GUVNL/GPRD/PiC Tech Specs /RP-041/Tech Specs /513

Sub.: Proposal for Amendments/changes in existing technical specifications with Submission of draft for Concurrence/Confirmation of CE of all DISCOM for Amendment of Technical Specifications of Maintenance free, Ready capsule, Pipe-in-Cage (PiC) type Earthing for HT/LT Distribution network.

TECHNICAL SPECIFICATIONS FOR MAINTENANCE FREE, ECO-FRIENDLY, READY CAPSULE, PIPE-in-CAGE (PiC) TYPE EARTHING SYSTEM

Drawing No.: GPRD-16 (Rev.1)

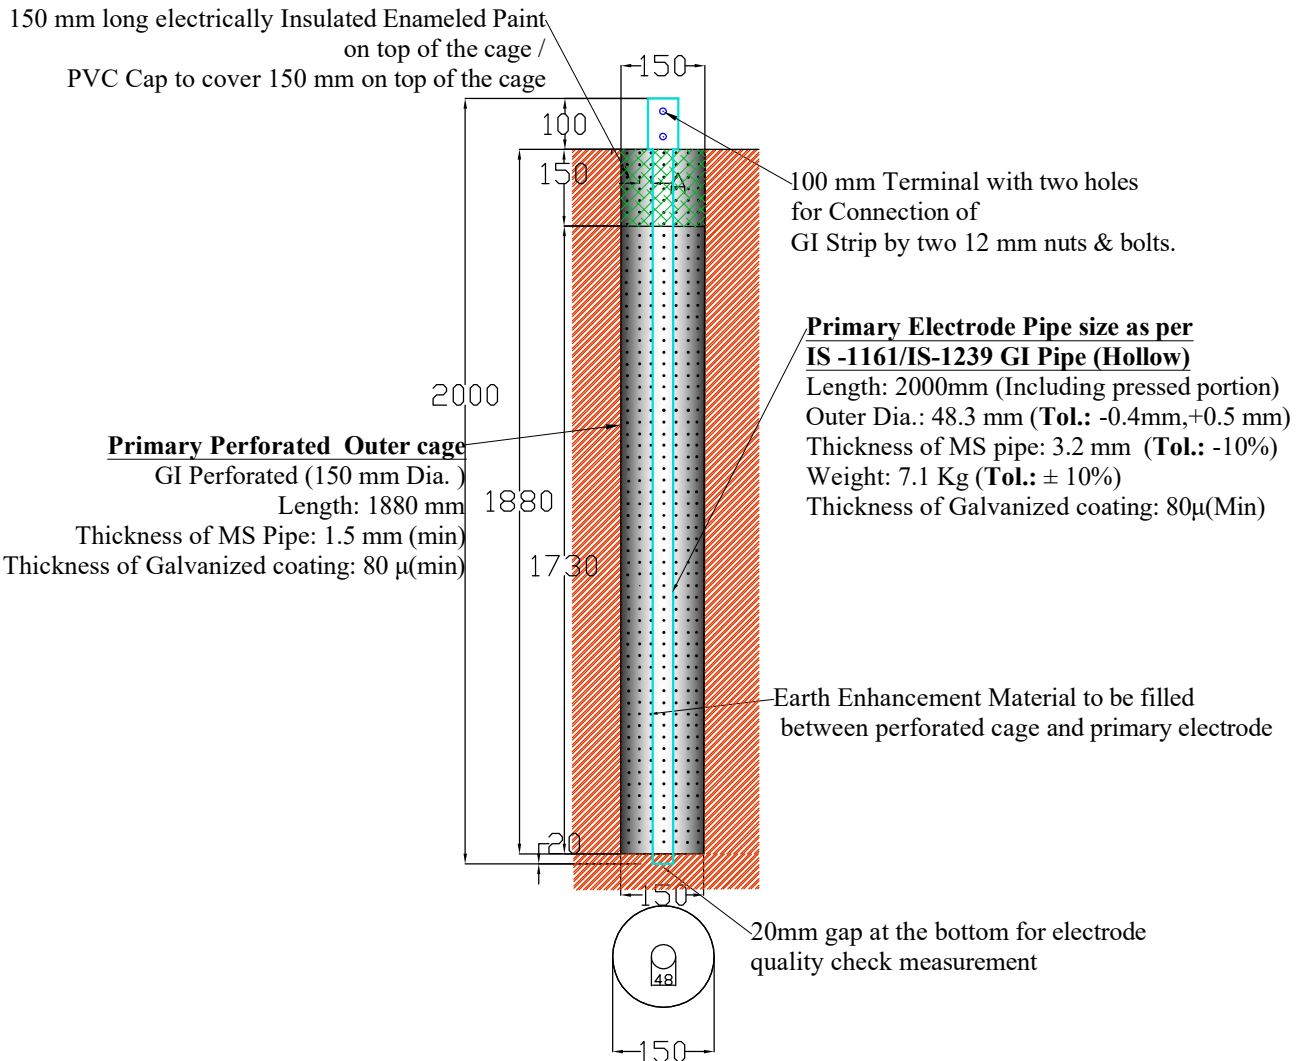
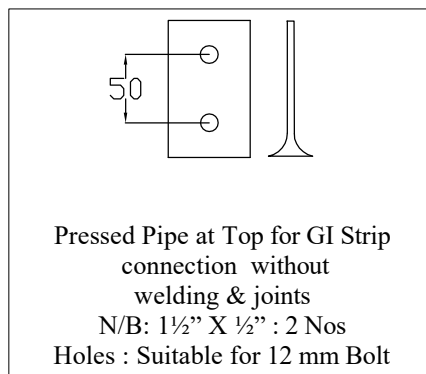
DRAWING					
1	Drawing No. GPRD-16 & 17 (Revision-2)	1. Dist. Between two holes in 100mm terminal= 25mm 2. Dia. of Primary Electrode in top view= 48mm	1. Dist. Between two holes in 100mm terminal= 50 mm 2. Dia. of Primary Electrode in top view= 48.3 mm	Typographical error	Incorporated

Sr. No.	Clause No.	Old Clause	Proposed Changes	Reason for proposed changes	GPRD's Comment
2	Drawing No. GPRD-16 (Revision-2)	Perforated Outer cage GI Perforated (150 mm Dia.) Length: 1880 mm Thickness of MS Pipe: 1.5 mm (min) Thickness of Galvanized coating: 80 μ(min	Perforated Outer cage GI Perforated (150 mm Outer Dia.) (min.) Length: 1880 mm(Tolerance (-1%, + not limited)) Thickness of MS Pipe: 1.5 mm (min) Thickness of Galvanized coating: 80 μ(min)	To incorporate tolerances in draw	Incorporated
3	Drawing No. GPRD-17 (Revision-2)	Perforated Outer cage GI Perforated (150 mm Dia.) Length: 2880 mm Thickness of MS Pipe: 1.5 mm (min) Thickness of Galvanized coating: 80 μ(min)	Perforated Outer cage GI Perforated (150 mm Outer Dia.) (min.) Length: 2880 mm(Tolerance (-1%, + not limited)) Thickness of MS Pipe: 1.5 mm (min) Thickness of Galvanized coating: 80 μ(min)	To incorporate tolerances in draw	Incorporated

Sr. No.	Drg. No.	Dimensions in Revised Drawing	Proposed Suggestion/ Comment	Justification
1	Drawing No. GPRD-16 & 17 (Revision-2)	1. Dist. Between two holes in 100mm terminal= 25mm 2. Dia. of Primary Electrode in top view= 48mm	1. Dist. Between two holes in 100mm terminal= 50 mm 2. Dia. of Primary Electrode in top view= 48.3 mm	Typographical error

2	Drawing No. GPRD-16 (Revision-2)	<u>Perforated Outer cage</u> GI Perforated (150 mm Dia.) Length: 1880 mm Thickness of MS Pipe: 1.5 mm (min) Thickness of Galvanized coating: 80 µ(min)	<u>Perforated Outer cage</u> GI Perforated (150 mm Dia.) (min.) Length: 1880 mm (Tolerance (-1%, + not limited)) Thickness of MS Pipe: 1.5 mm (min) Thickness of Galvanized coating: 80 µ(min)	To incorporate tolerances in drawing
3	Drawing No. GPRD-17 (Revision-2)	<u>Perforated Outer cage</u> GI Perforated (150 mm Dia.) Length: 2880 mm Thickness of MS Pipe: 1.5 mm (min) Thickness of Galvanized coating: 80 µ(min)	<u>Perforated Outer cage</u> GI Perforated (150 mm Dia.) (min.) Length: 2880 mm (Tolerance (-1%, + not limited)) Thickness of MS Pipe: 1.5 mm (min) Thickness of Galvanized coating: 80 µ(min)	To incorporate tolerances in drawing
		<u>PIC Capsule Dimensions</u> 1. Length: 2000 mm 2. Length: 1880 mm 3. Length: 1730 mm	<u>PIC Capsule Dimensions</u> 1. Length: 2000 3000 mm 2. Length: 1880 2880 mm 3. Length: 1730 2730 mm	Typographical error

7	Drawing No. GPRD-16 (Rev-1)	Primary Electrode Pipe size as per IS -1161/IS-1239 GI Pipe (Hollow) Length -2000mm (Min) (Including pressed portion) Outer Dia. - 48 mm ($\pm 10\%$) Thickness of MS pipe- 3.2 mm (Min) (+0.4mm, -0.8 mm) Weight- 7.1 Kg ($\pm 10\%$) Thickness of Galvanized coating- 80μ(Min) Perforated Outer cage GI Perforated (150 mm Dia.) Length - 1880 mm Thickness of MS Pipe - 1.5 mm (min) Thickness of Galvanized coating - 80 μ(min) Perforated Cage Holes A = 45 to 70 mm distance between holes (Horizontally and vertically)	Primary Electrode Pipe size as per IS -1161/IS-1239 GI Pipe (Hollow): NB=40mm Length -2000mm (Min) (Including pressed portion) Outer Dia. - 48 mm ($\pm 10\%$) (47.9 mm - 48.8 mm) Thickness of MS pipe- 3.2 mm (Min) (+0.4mm, - 0.8 mm) (- 10 %) Weight- 7.1 Kg ($\pm 10\%$) Thickness of Galvanized coating- 80μ(Min) Perforated Outer cage GI Perforated (150 mm Dia.) (min.) Length - 1880 mm (min.) Thickness of MS Pipe - 1.5 mm (min) Thickness of Galvanized coating - 80 μ(min) Perforated Cage Holes: Dia. 3.5mm or lesser A = 45 to 70 mm distance between holes (Horizontally and vertically)	To incorporate tolerances in various dimensions of perforated cage as mentioned in Specification Cl. No. 4(a). To incorporate tolerances in hole dia. of perforated cage as mentioned in Specification Cl. No. 4(a).

Drawing No.: GPRD-17 (Revision:1)

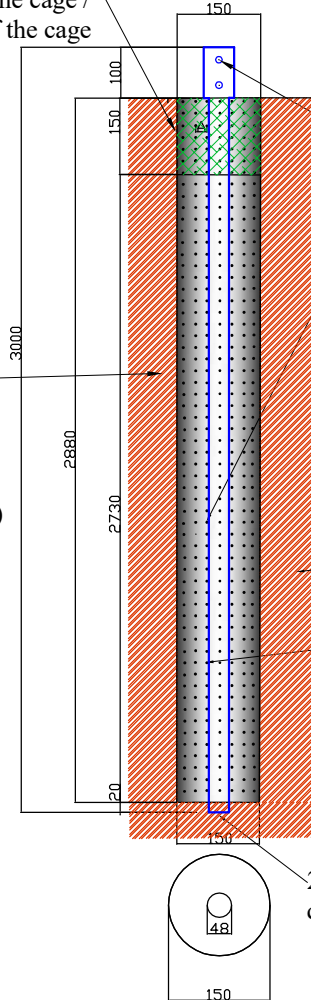
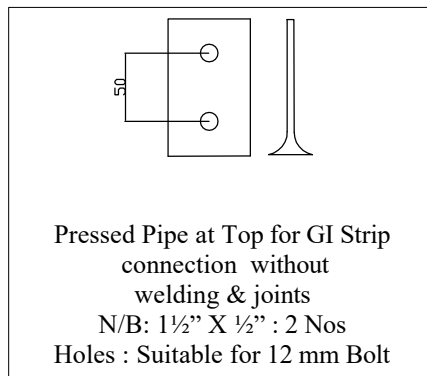
7	GPRD-17 revised drawing	Drawing of 3000 mm rod and length mentioned is 2000 mm.	it should be as per 3000 mm.	Typographical error.	Incorporated

Drawing No. GPRD-17 (Rev-1)	<u>Perforated Outer cage</u> GI Perforated (150 mm Dia.) Length - 2880 mm Thickness of MS Pipe - 1.5 mm (min) Thickness of Galvanized coating - 80 µ(min)	<u>Perforated Outer cage</u> GI Perforated (150 mm Dia.) (min.) Length - 2880 mm (min.) Thickness of MS Pipe - 1.5 mm (min) Thickness of Galvanized coating - 80 µ(min)	To incorporate tolerances in various dimensions of perforated cage as mentioned in Specification Cl. No. 4(a).
	<u>Perforated Cage Holes</u> A = 45 to 70 mm distance between holes (Horizontally and vertically)	<u>Perforated Cage Holes: Dia. 3.5mm or lesser</u> A = 45 to 70 mm distance between holes (Horizontally and vertically)	To incorporate tolerances in hole dia. of perforated cage as mentioned in Specification Cl. No. 4(a).
